July 25, 2006
File: 84438704, 84400042

Reference: Clover Valley DEIR
Response to Letter of June 21, 2006

From: Gonzalez, Davina
Sent: Wednesday, August 09, 2006 7:27 AM
To: Doug Moore (dmoore@westyost.com)
Cc: O'Hagan, Michael
Subject: Clover Valley Lakes Hydrology/Hydraulics

SUBJECT: Clover Valley Project No.: 279-00-05-04.06

Hydrograph Upstream of Pond 1 (20917)
100-year event

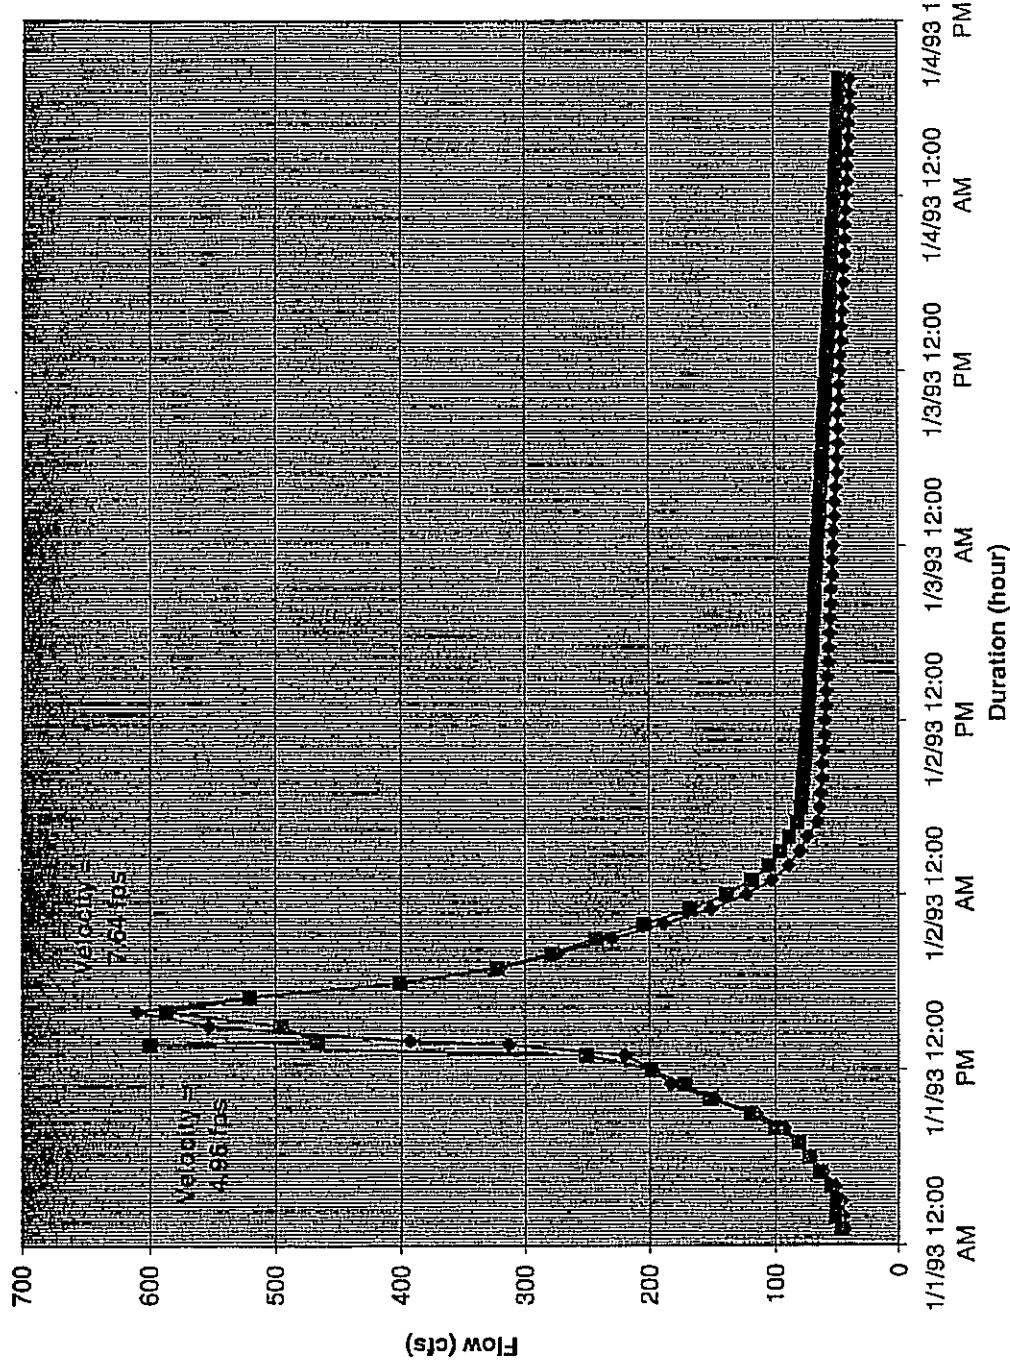
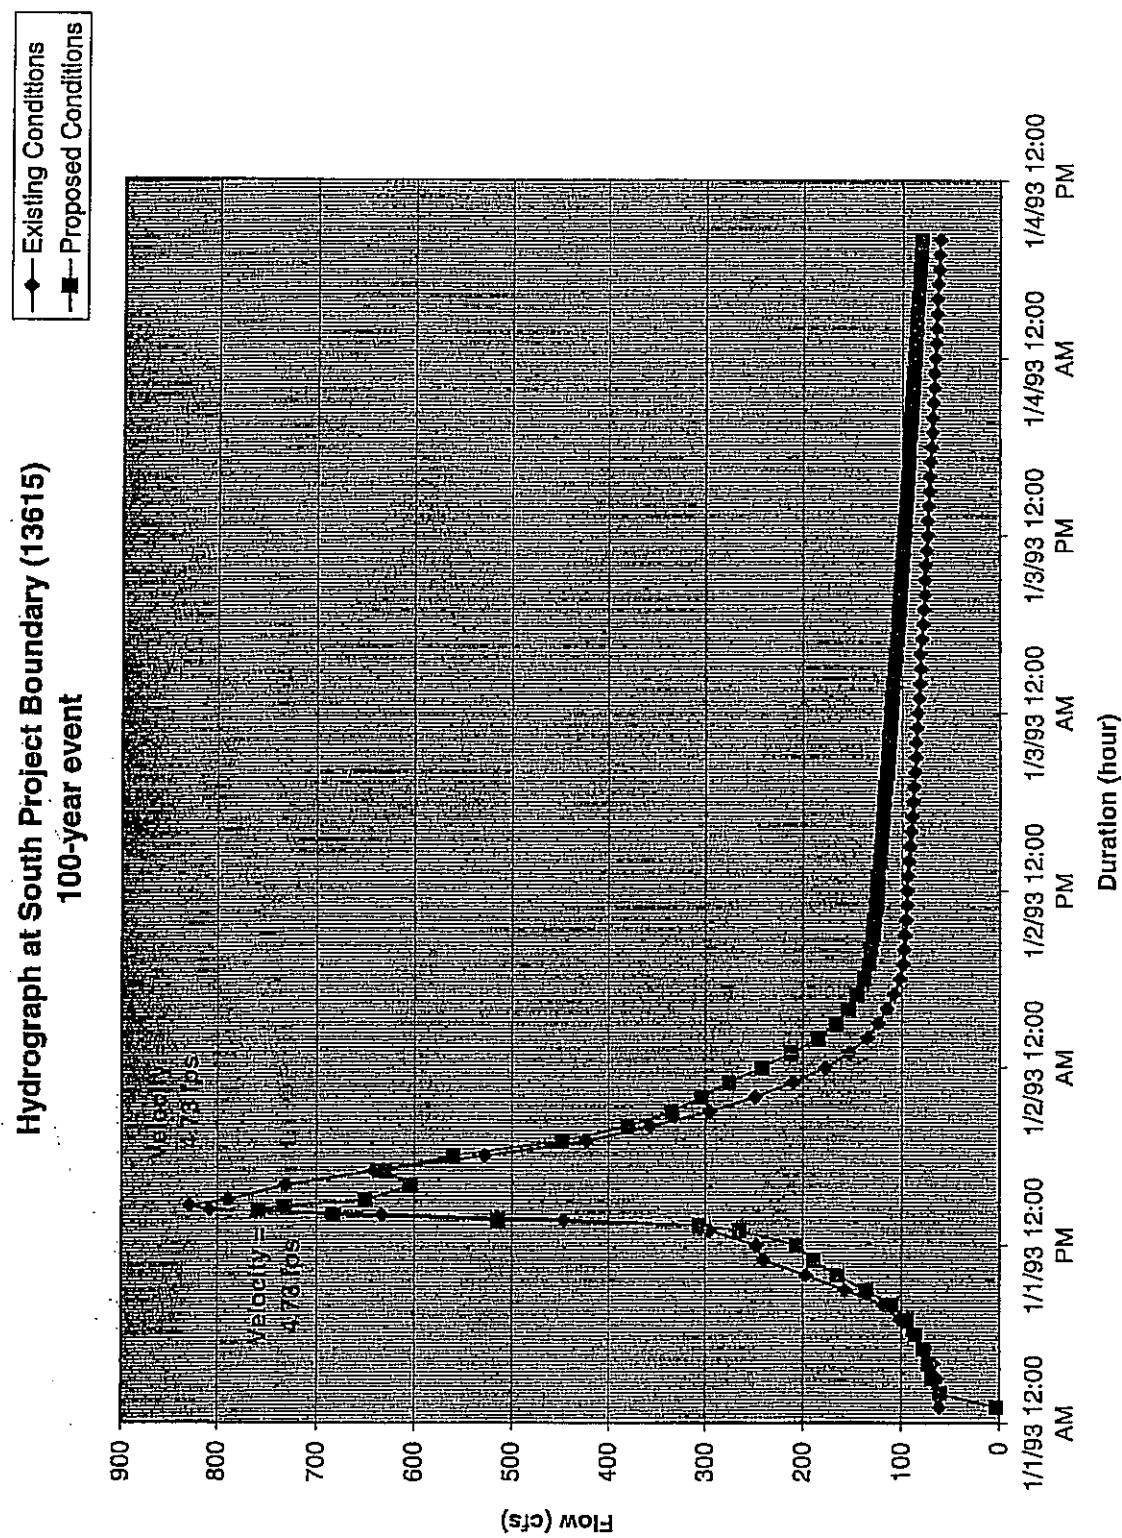
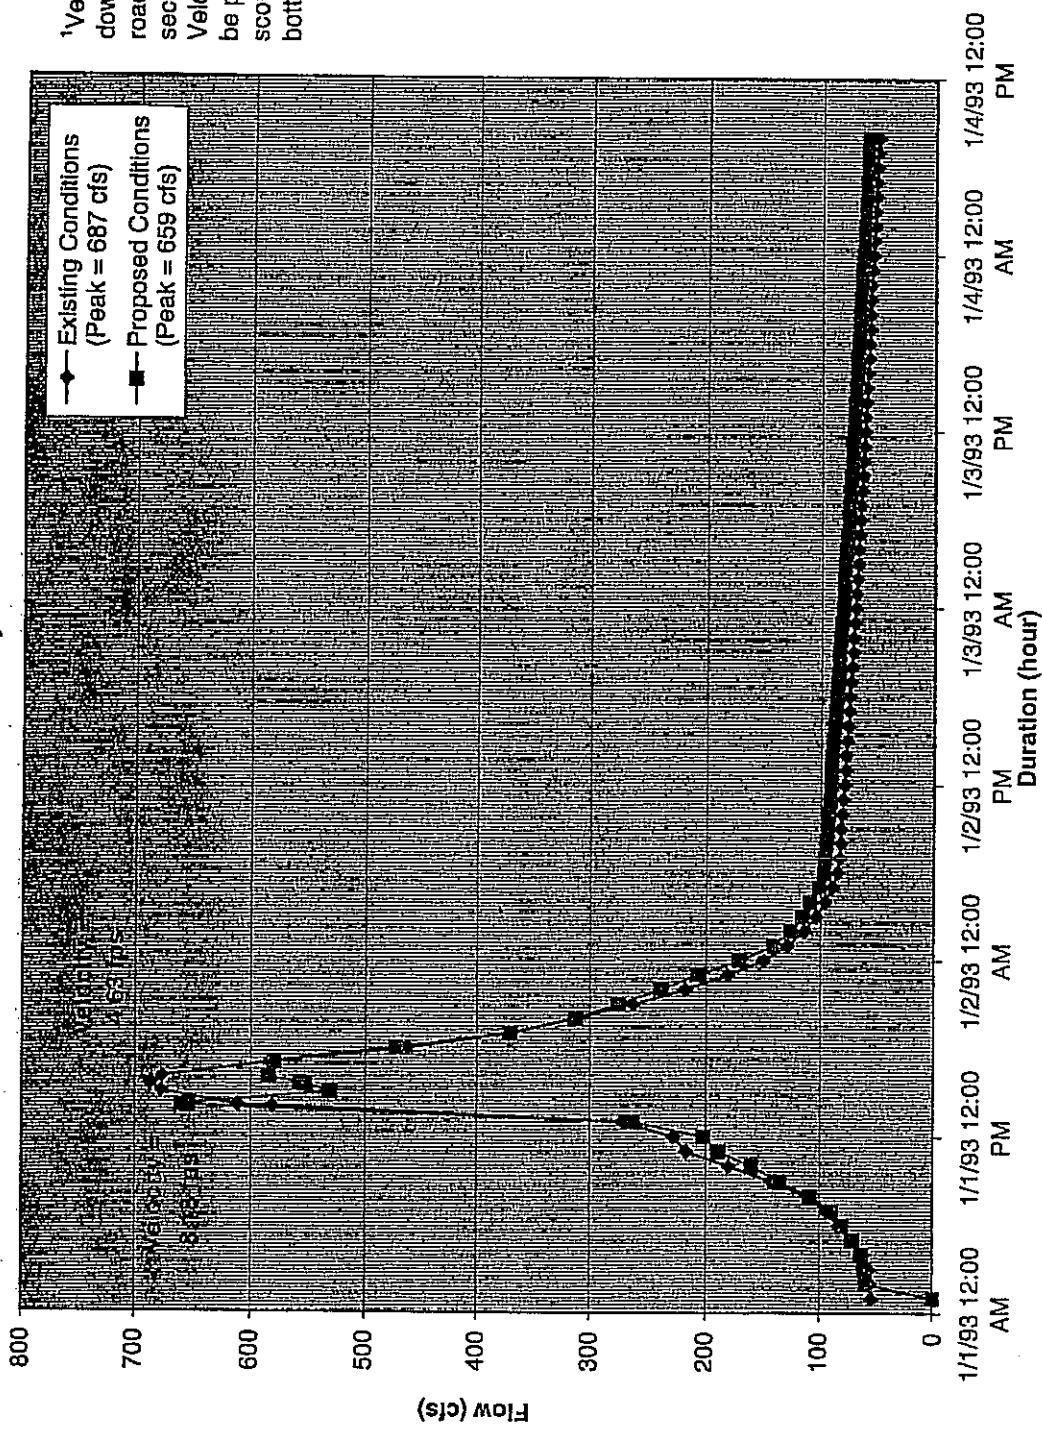
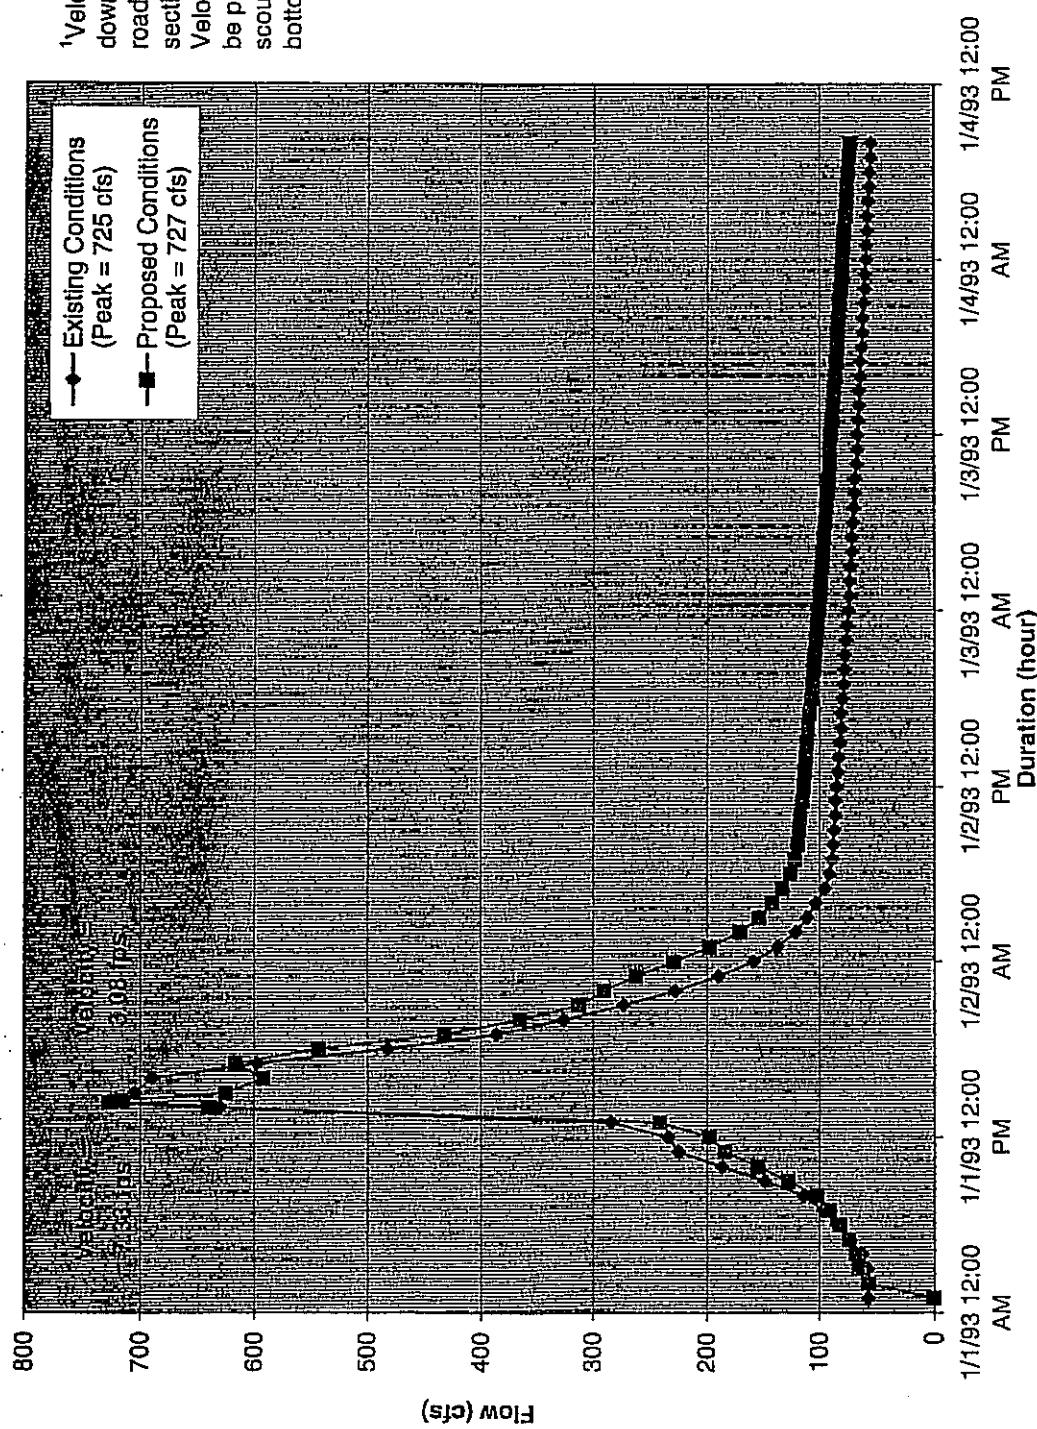
3) Hydrographs - Please add the section location of the hydrograph and add the peak velocities. The hydrograph for Outfall of Pond 1 shows a peak flow of about 970 cfs. This is inconsistent with EIR, Appendix O, Table 3 which list the peak flow as 659 cfs. The hydrographs at the south project boundary also do not agree with the values in Table 3. Table 3 was developed from data from the Spink Tech Memo dated 2-20-2001. Also, please provide similar hydrographs for the 10-year and 2-year storms. The input rain data for the HEC 1 model was in 5 minute increments. Please provide the output data in 5 minute increments also (since providing hourly data points may miss the peak flows). The hydrographs (10- and 100-year) have been redone to represent peak flows in the ponds, which are the flows presented in Appendix O, Table 3. Cross-section labels have been added to correspond with the cross-section exhibit. Also included are the HEC-1 outputs for 10- and 100-yr events.

¹Velocity occurs at downstream side of road crossing (cross-section 17260). Velocity dissipator do be provided to reduce scour of channel bottom.
